Palmdale Hybrid Power Project (PHPP): Further Energy Commission Staff Clarification of Data Request 22, March 3, 2009

Energy Commission Data Request 22, Revised by the Applicant on 1/29/09 and Further Revised by Staff on 1/30/09 (verbatim):

Staff's Clarification of Geographic Scope of Data Request 22

California Energy Commission DR22
Figure 1

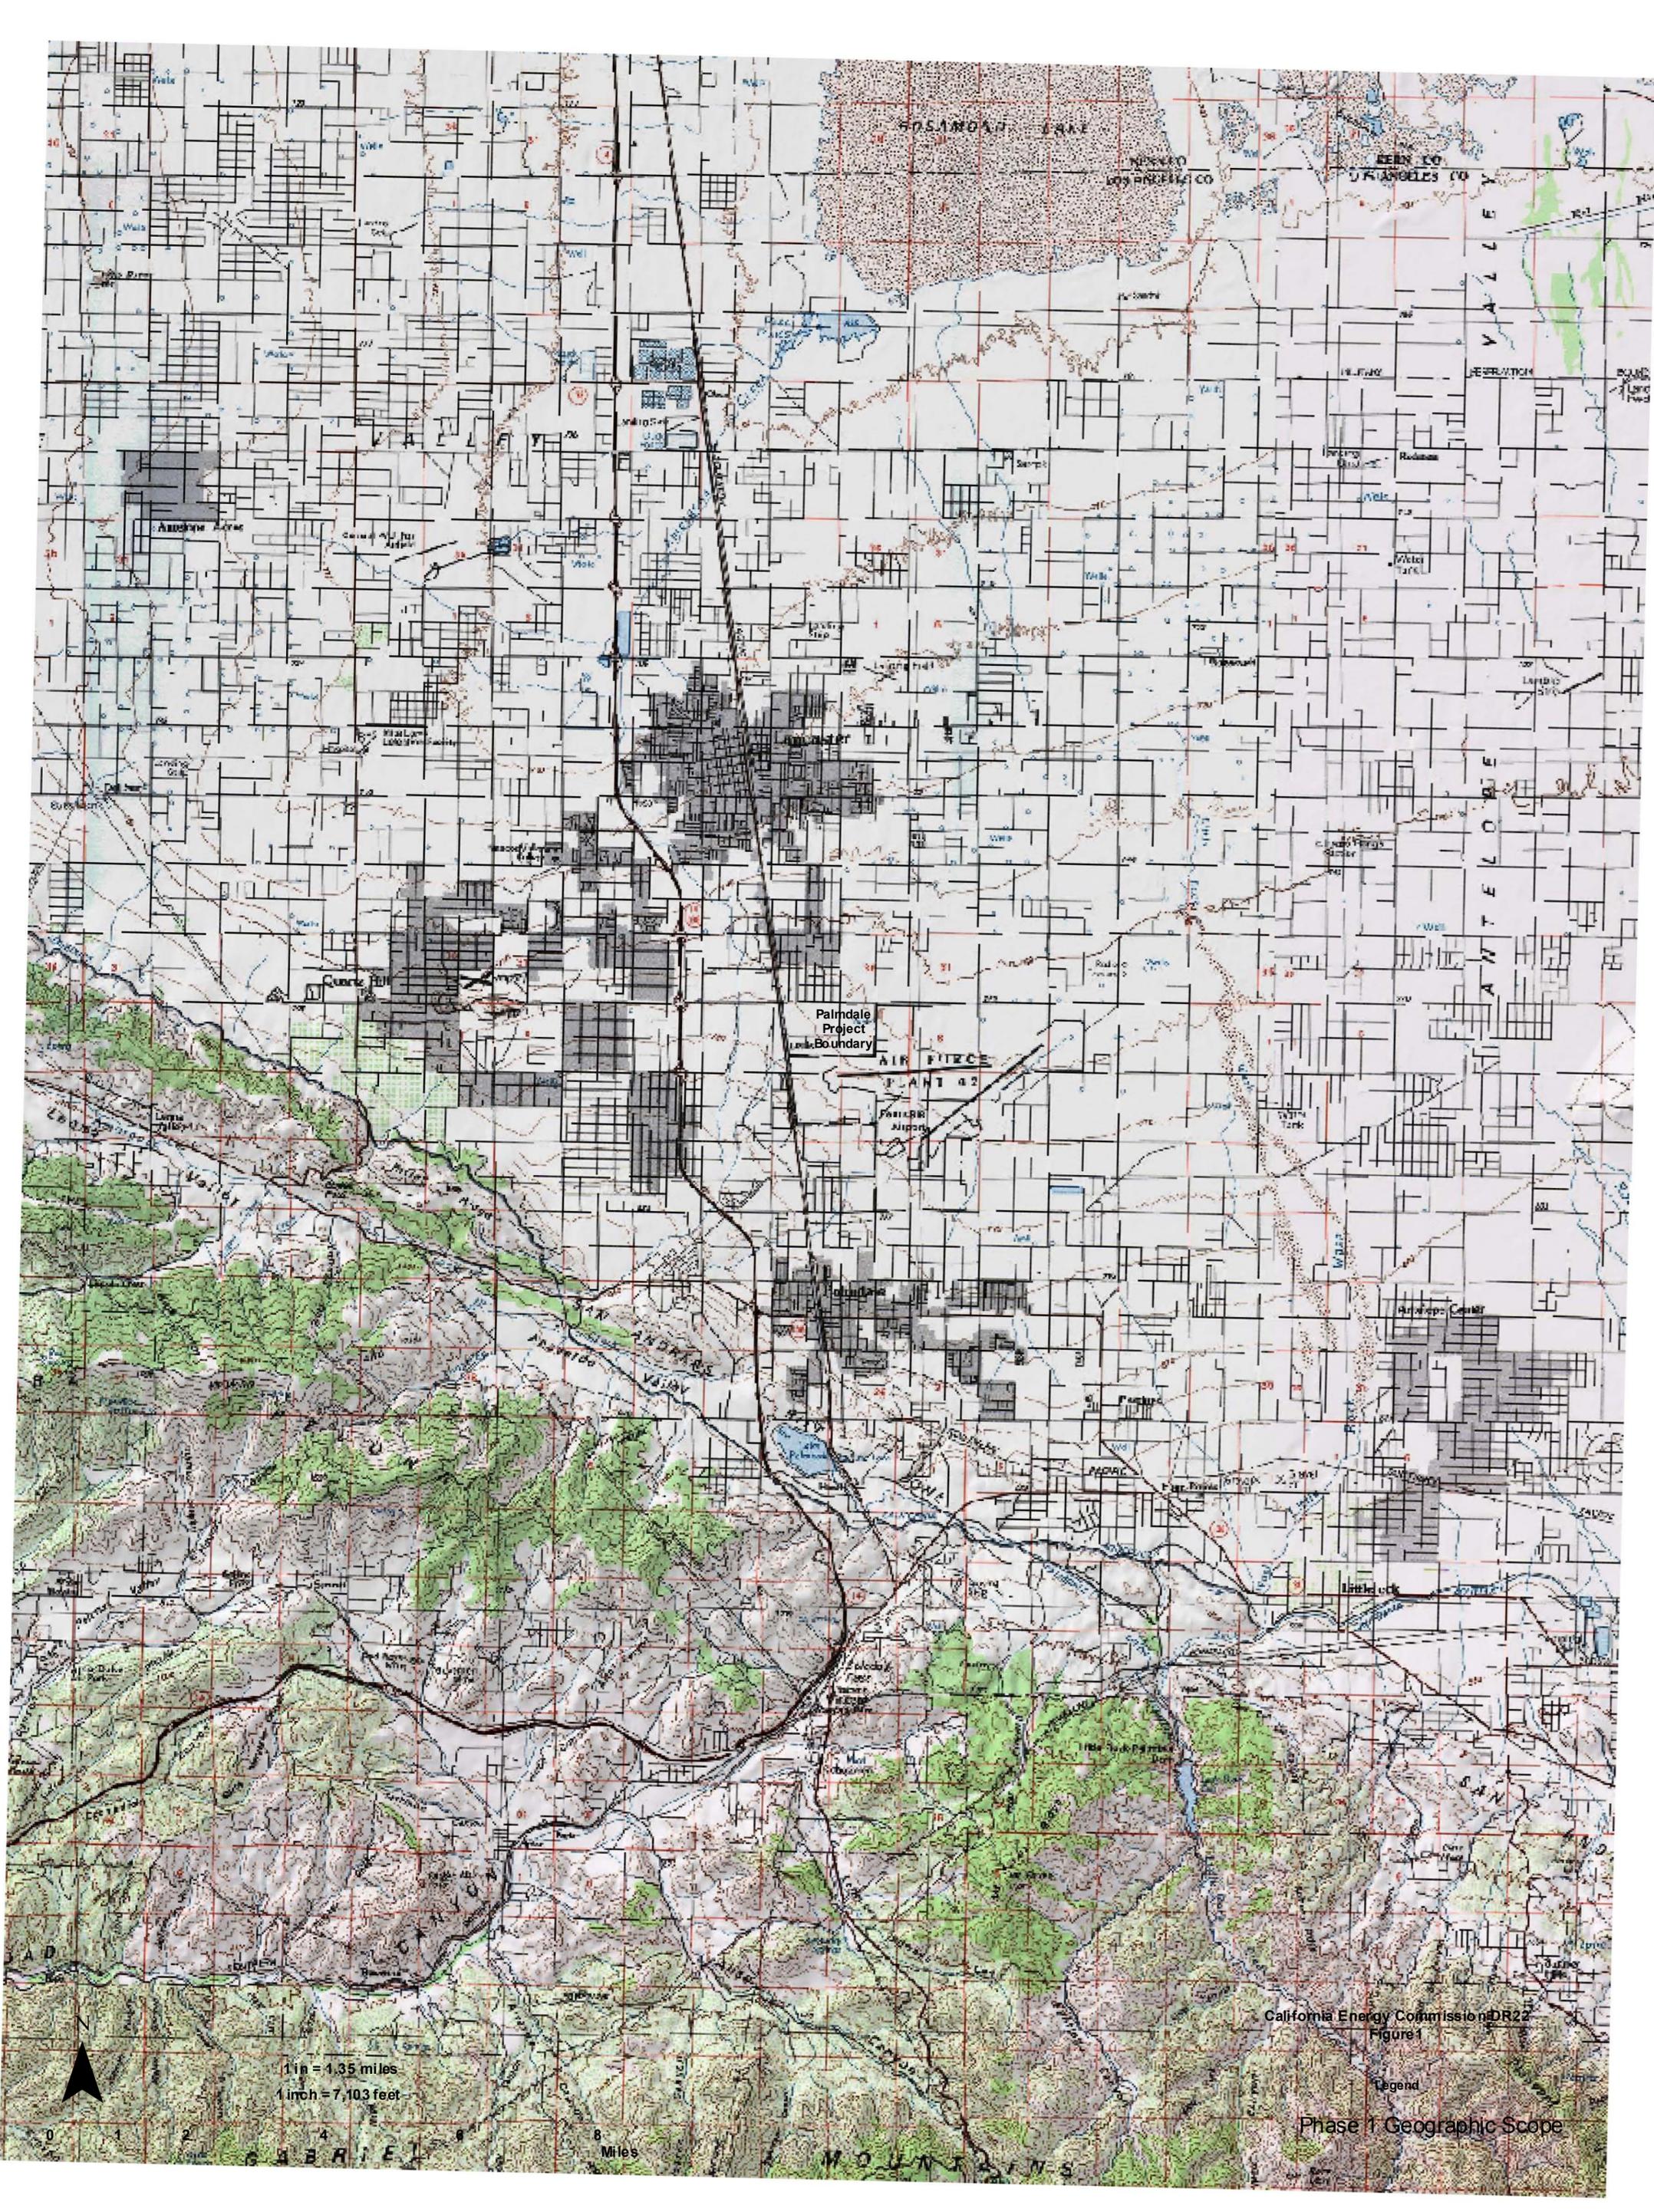
The specific area for which staff is requesting a “big picture” summary is outlined on the attached figure (Energy Commission DR22 Figure 1). It is necessarily large to include the project site’s landform and those nearby landforms with which it has a historical geomorphic relationship. So the Phase 1 study area includes:

- the source of and the transporting vectors for the project site’s sediments—the San Gabriel Mountains and the canyons in the foothills of the San Gabriel Mountains to the south and southwest;
- the project site’s landform—the merged alluvial fans forming a bajada extending to the northwest and southeast; and
- the landform of the proposed project’s most extensive component, the transmission line—the slightly sloping plain to the north and northeast dissected by numerous shallow washes, which further drain the two higher landforms.
